1989 - 1991 Corvette: Service Bulletin: No/Delayed Reverse When Cold

Subject: NO/DELAYED REVERSE WHEN COLD INSTALL REV.
INPUT CLUTCH SEAL

Bulletin Number: 91-493-7A - (03/11/1992)

**SUBJECT: ----- No Reverse/Delayed Reverse Cold (Install Long
Lipped Reverse Input Clutch Piston Outer Seal)**

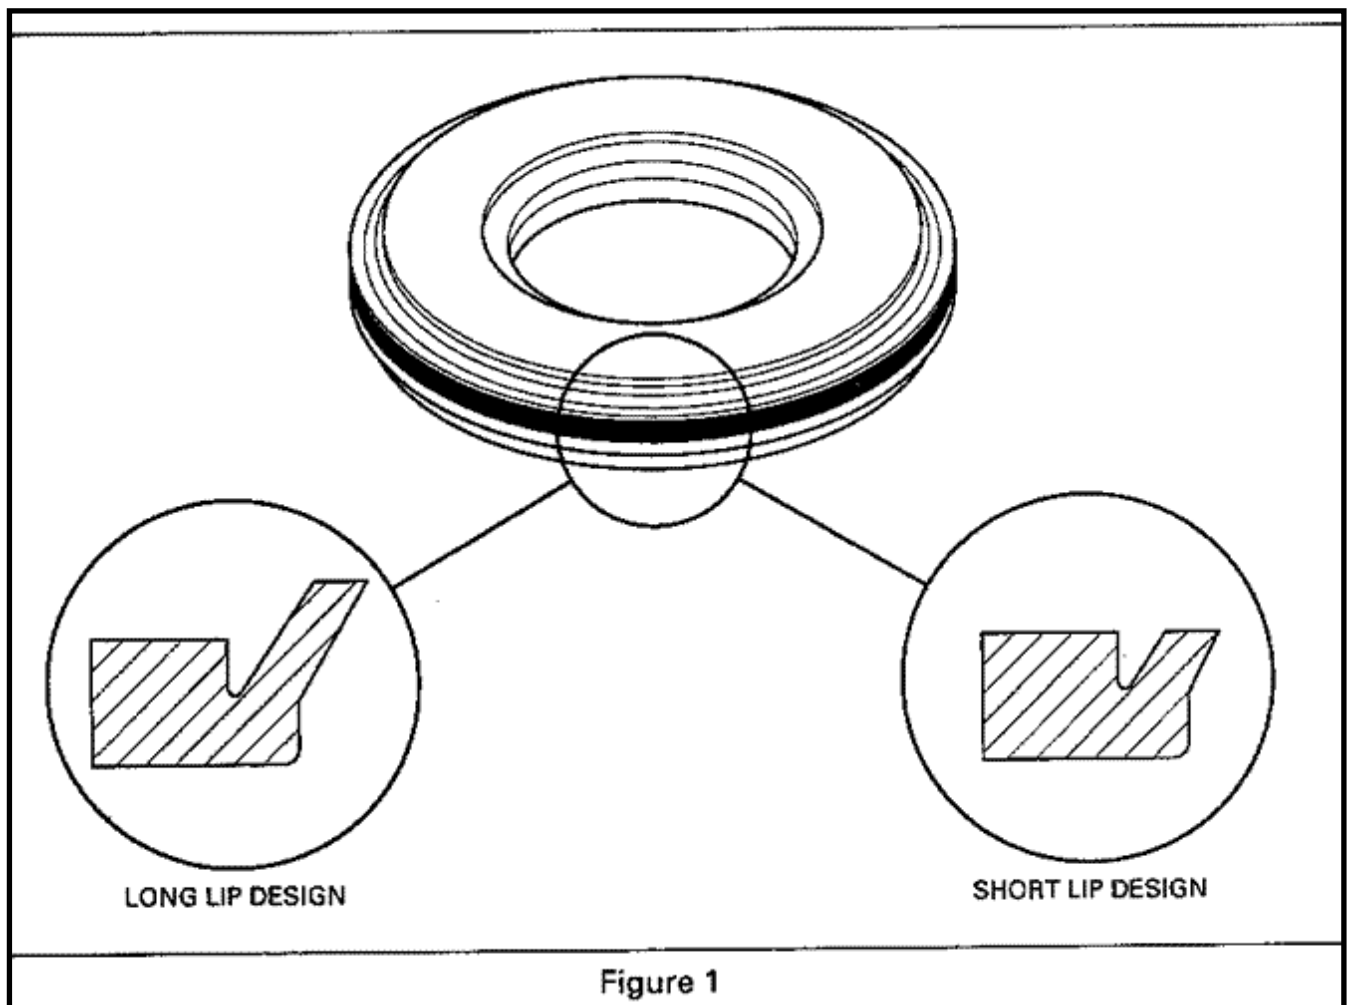
If a transmission has a 'no reverse' or 'delayed reverse' condition, inspect the reverse input clutch piston outer seal. Determine if the seal is a 'short lip' or 'long lip' design by comparing it to Figure 1. If it is a short lip design, replace it with a long lip seal contained in the service packages listed under Service Parts Information.

If the reverse input clutch piston outer seal is a long lip design, or the newly installed long lip seal doesn't alleviate the delayed reverse condition, the reverse input clutch housing may be out of round. Inspect the housing and replace if necessary.
